BROWNS FERRY NUCLEAR PLANT, UNIT NO. 2

AMENDMENT TO FACILITY OPERATING LICENSE

Amendment No. 62
License No. DPR-52

ATTACHMENT TO LICENSE AMENDMENT NO. 62

Figure 3.6-1

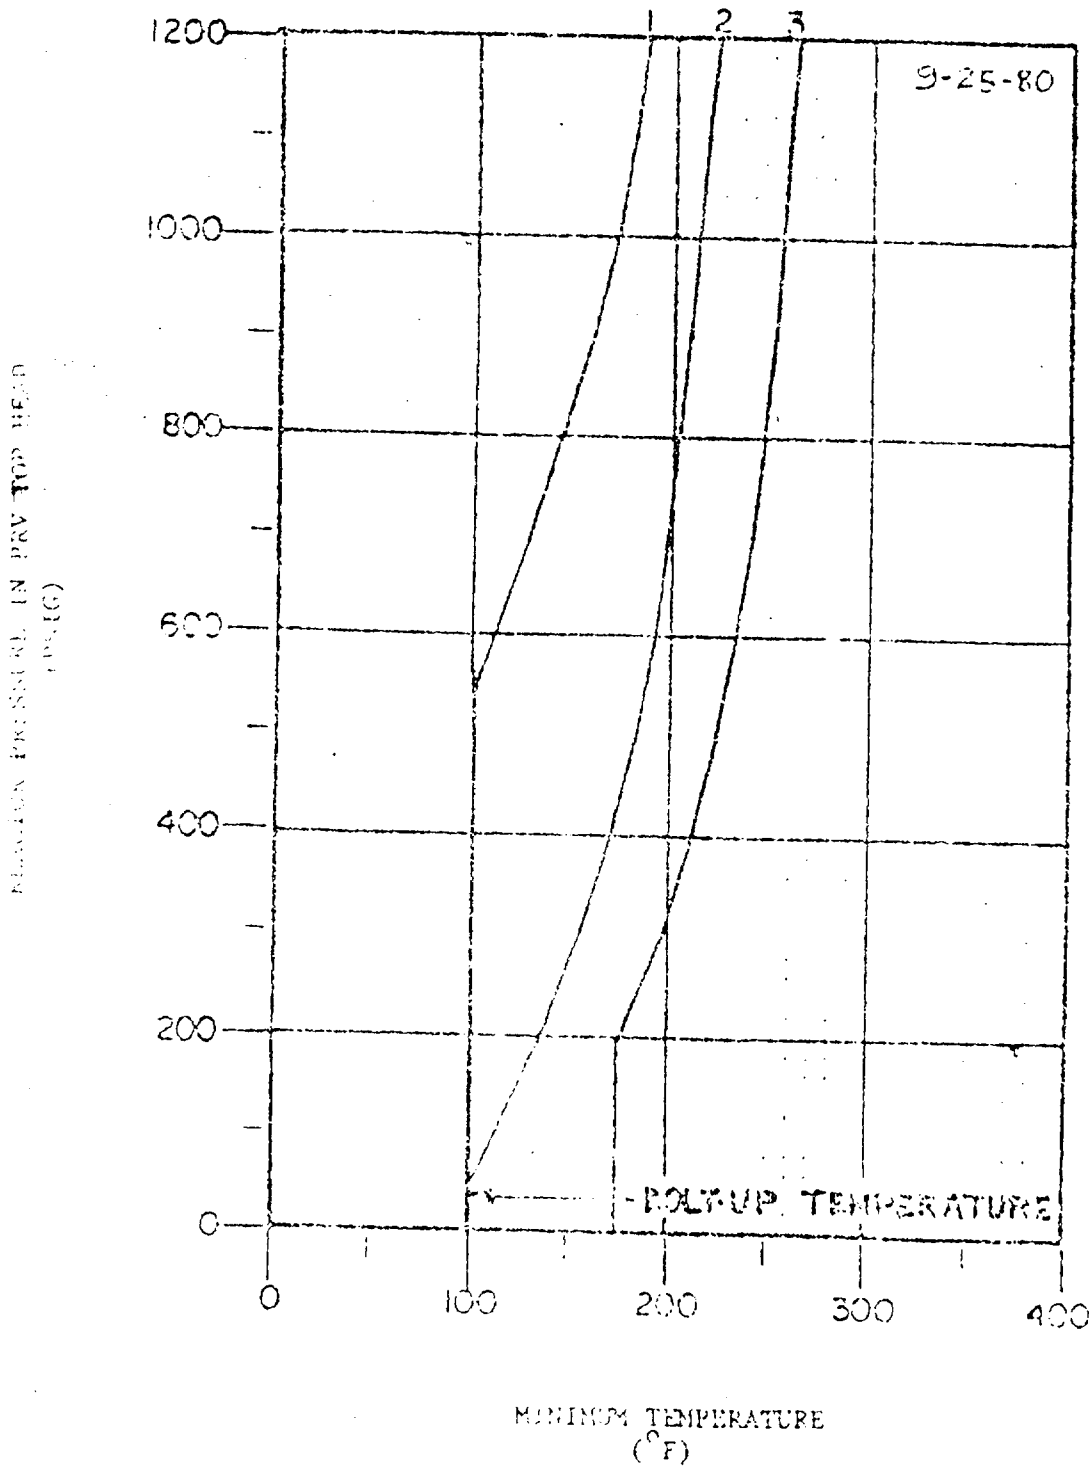
The proposed changes on page 188 of the Unit 1 and 2 Technical Specifications and on page 201 of the Unit 3 Technical Specifications is to substitute a revised Nil Ductility Temperature (NDT) operating curve. These curves specify the minimum temperature that the reactor vessel must be at for the range of primary coolant pressures. The upper portion of the curves provides an additional 20°F shift from the original curves for protection because of uncertainty of radiation damage. The lower portion of curves 2 and 3 reflect the limiting conditions for protection of the feedwater nozzles from degradation. This lower portion includes the 40°F conservatism for nuclear heatup. These proposed curves are more conservative than those in the present technical specifications and have been administratively imposed. The proposed changes are acceptable.

Notes
These curves are
shifted 30°F to the
right of the original
set of curves to
include a ΔK_{eff} of
30°F. This shift will
allow these curves to
used thru 4.0 BFPY.
